SUTHERLAND SHIRE COUNCIL ASSESSMENT REPORT

Panel Reference	PPSSSH-145
DA Number	DA23/0420
LGA	Sutherland Shire Council
Proposed Development	Demolition of existing structures and construction of a mixed use development (health service facility and residential units) with Torrens title and stratum subdivision
Street Address	8-20 Hinkler Road, Caringbah and 319-333 Taren Point Road, Caringbah
Applicant/Owner	Hinkler Avenue No 1 Pty Ltd
Date of DA lodgement	13 July 2023
Number of Submissions	6 submissions were received
Recommendation	Refusal
Regional Development Criteria (Schedule 6 clause 5 of the SEPP (Planning Systems) 2021	The proposed development has a capital investment value of more than \$5 million, estimated at \$71,061,819.
List of all relevant s4.15(1)(a) matters	<ul style="list-style-type: none"> • State Environmental Planning Policy (Planning Systems) 2021 Chapter 2 State and Regional Development. • State Environmental Planning Policy (Housing) 2021. <ul style="list-style-type: none"> ◦ Chapter 2 Affordable Housing • State Environmental Planning Policy No. 65 – Design Quality of Residential Flat Development (SEPP 65) (despite its repeal and inclusion in the Housing SEPP m

Figure 7: East elevation of Building A (DA301 Rev A)

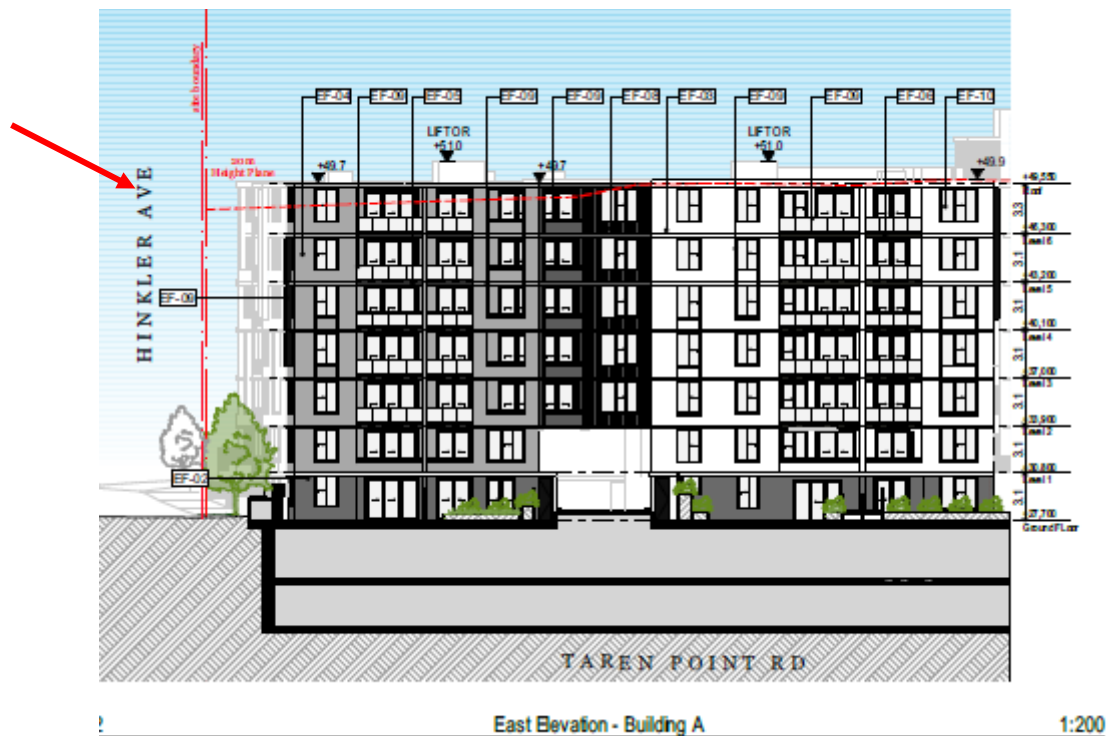
The proposal seeks a maximum height of 23.3 metres – 3.3m above the maximum height or a variation of 16.5% if the building height incentive is applicable under SSLEP clause 6.21(4). **Figure 6** below indicates the extent of the height non-compliance in that circumstance. The greatest height exceedance arises from the lift overrun on Building A (3.3m). Some other exceedances arise from lift overruns on Buildings B and C, and part of the habitable area of dwellings being above the height plane (e.g. up to 0.85m for the north eastern corner of Building B and up to 1.45m for the south eastern corner of Building A.) The HSF has a height exceedance of 0.8m from the lift overrun.

Figures 7 and 8 demonstrate the extent to which the height exceedances are encroaching into habitable space.

Figure 9: Map 4 of SSDCP 2015

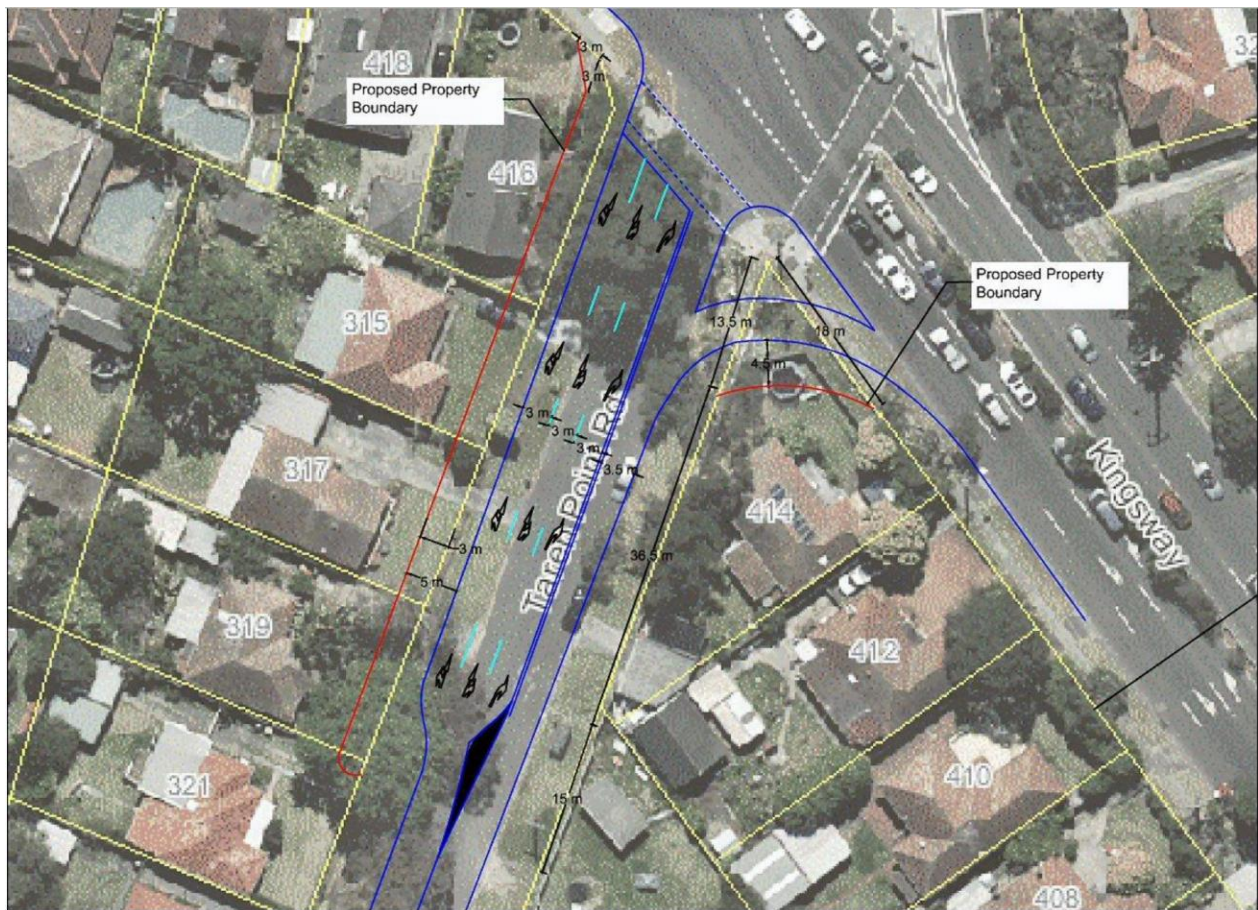
Part of Lots 10 and 11 in DP35463 (being 319-321 Taren Point Road) are identified as being for land acquisition and are subject to clause 5.1 of SSLEP 2015. Clause 5.1A requires that development consent must not be granted to any development on land which is identified for such acquisition unless the consent authority is satisfied that the development is of a kind or is compatible with development of a kind that may be carried out on land in an adjoining zone and that the use will cease no later than 5 years after development consent is granted. A series of considerations are set out to assist in making that determination.

The proposal indicates by virtue of the Building C basement not extending within the acquisition area that it is possible to dedicate that part which is identified in the SSLEP 2015 for land acquisition. The basement is proposed to that boundary and the HSF above is setback approximately 2.5m from the area. The road widening intended for this part of Taren Point Road has yet to be completed but expectations are that this would occur as per the plan set out in SSDCP 2015 (refer **Figure 9** below) similar to the sites to the north. No further details about any proposed dedication are included in the proposal documentation.

Figure 10 – North Elevation of Building B showing relationship to street level.

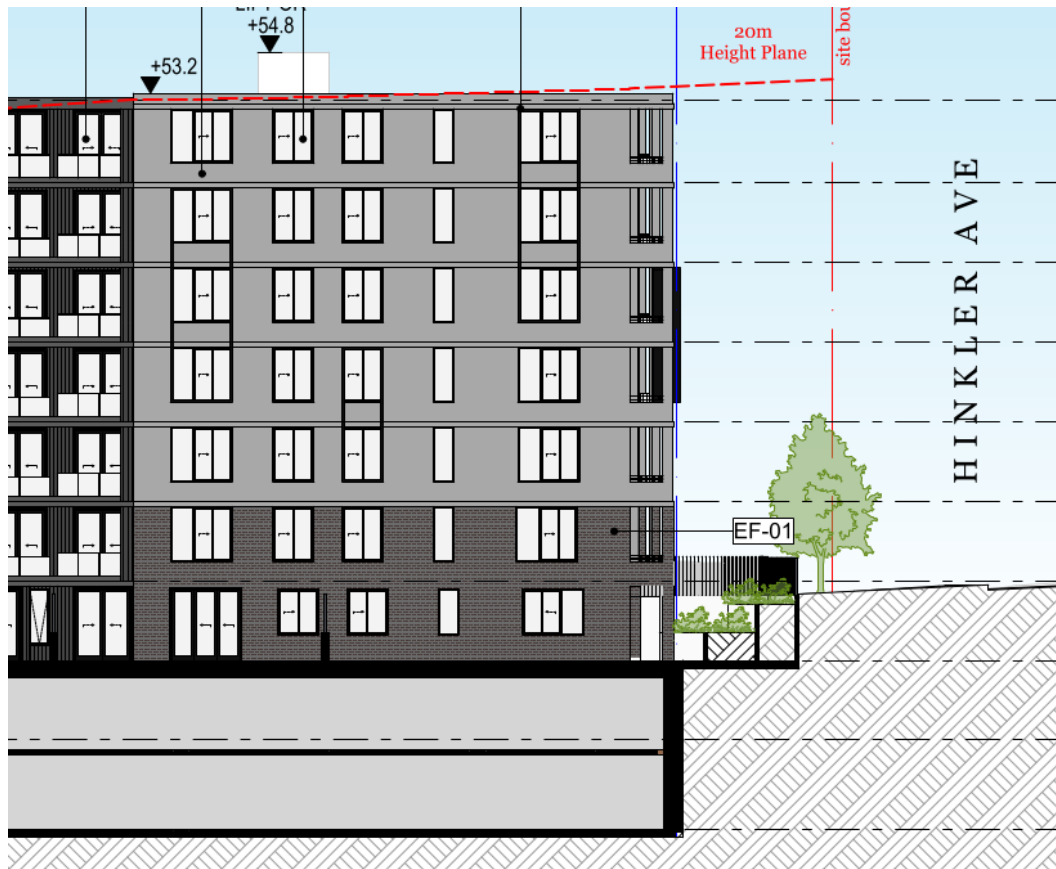
There are a large number of ground floor and level 1 apartments which are set below both the existing natural ground level and the public domain level at the boundary. See example in **Figure 10** below.

The relevance of units being below ground is that it impacts on amenity by virtue of a lack of privacy from the public domain, solar access and natural surveillance. These are all matters which relate to the interface with the public domain. Section 3C of the ADG advises that dwellings slightly elevated by up to 1m from the footpath have enhanced privacy. Objective 3F-2 (visual privacy) includes design guidance to raise apartments/private open space above the public domain. Objective 4A-1 regarding solar access seeks to optimise the number of apartments getting solar access.

It is clear that the vast majority of ground floor and level 1 apartments are set below natural ground level and/or the public domain. Retaining walls within the deep soil setbacks and private open spaces of the units will be required which impacts on potential landscaping. A defensive response to landscaping between the public domain and the through site link to the apartments is evident as a result of seeking to obtain visual privacy to the private open spaces and dwellings at ground level. This is demonstrated by the montage in DA319 Rev A (**Figure 11**) for the north west corner of Building A where Level 1 adjacent to the Hinkler Avenue Communal open space entry is not visible (only 5 of 6 levels are visible).
